UNITED STATES PATENT AND TRADEMARK OFFICE

APPLICATION NO.	FILING DATE	FIRST NAMED INVENTOR	ATTORNEY DOCKET NO.	CONFIRMATION NO.
10/562,131	12/23/2005	Takashi Kakiuchi	2005_1919A	5564
52349 7590 04/11/2008 WENDEROTH, LIND & PONACK L.L.P. 2033 K. STREET, NW SUITE 800 WASHINGTON, DC 20006				
EXAMINER				
ITALIANO, ROCCO				
ART UNIT		PAPER NUMBER		
3746				
MAIL DATE		DELIVERY MODE		
04/11/2008		PAPER

Office Action Summary

DETAILED ACTION

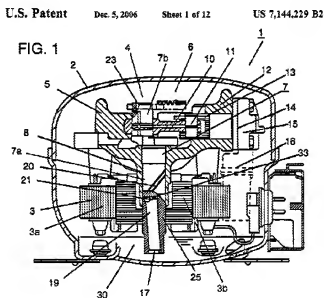
With respect to claim 1, Ishida et al. discloses a hermetically sealed compressor particularly defining similar features as claimed by the applicant (see column 5 line 44 – column 6 line 13 and Fig. 1). Ishida et al. discloses: a hermetic compressor (1) comprising a sealed vessel or body (1) filled with freezer oil (30); an electromotive element (3) including a rotor (3b) and a stator (3a) housed or accommodated within the sealed vessel or body (1); a compressing element or compressing unit (6) which can be visually observed in Fig.1 as being accommodated within an upper region of the sealed vessel and being adapted for to be driven by the electromotive element; the compression element (6) being provided with a crankshaft or shaft (7) which can also be visually observed in Fig. 1 as extending vertically and having the rotor (3b) mounted thereon; Fig. 1 also illustrates a bearing (8) for supporting the shaft (7); a slanting channel or first oil pump (19) provided in the lower portion of the shaft and opening into

the freezer oil (30); a second oil pump comprising a spiral groove (20), provided on the outer periphery of the shaft (7), whereby the second oil pump is provided at the top end or above the first oil pump (19), and an inner peripheral wall surface of the rotor; as seen in Fig.1, the spiral groove (20) is provided along the outer periphery of the main crankshaft (7), whereby a third oil pump, provided above the second oil pump, is formed by the spiral groove (20) provided on the outer periphery of the shaft (7) and an inner peripheral surface of the bearing (8).

In regards to claim 2, it can be visually observed from Fig. 1 according to Ishida that the spiral groove (20) of the second and third oil pump is formed continuously.

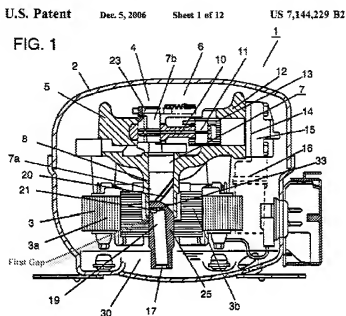
In regards to claim 3, Fig.1 according to Ishida illustrates the spiral groove (20) of the second and third oil pump as being provided on the outer periphery of shaft (7). It may be observed from Fig. 1 that the shaft on which the spiral groove (20) is provided is in communication with a first gap formed between the rotor (3b) and bearing (8)

therefore allowing for open communication between first gap and spiral groove (20) (see Fig. 1 labeled by the examiner for clarity).

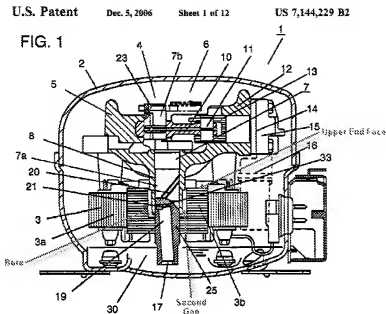
With respect to claim 5, Ishida discloses in Fig. 1 a rotor with an upper end face formed with a bore for receiving the bearing (8) whereby a second gap is formed between an inner peripheral surface of the bore and an outer peripheral surface of the bearing (see Fig. 1 label by the examiner for clarity).

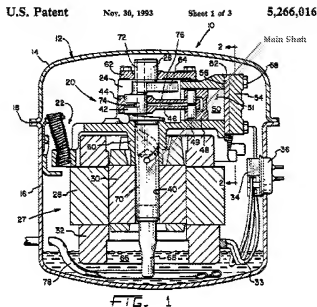
In regards to claim 11, Kandpal teaches of a hermetically sealed compressor wherein it may be visually observed in Fig. 1 that the element (60), analogous to the main bearing as designated by the applicant, is arranged in a comparable manner in which it (60) does not intersect a plane containing one end of the rotor core (30) adjacent the compressing element (20) and lying generally perpendicular to a longitudinal axis of the main shaft (labeled by examiner) (see Fig. 1).

With respect to claim 12, Fig. 1 according to Kandpal, also provided an illustrated teaching in which auxiliary shaft portion (26) provided coaxially of the main shaft portion (labeled by the examiner) with the eccentric shaft portion (42) intervening between the main shaft portion (labeled by the examiner) and the auxiliary shaft portion (26), and an auxiliary bearing (62) for supporting the auxiliary shaft portion (26) (see Fig. 1).
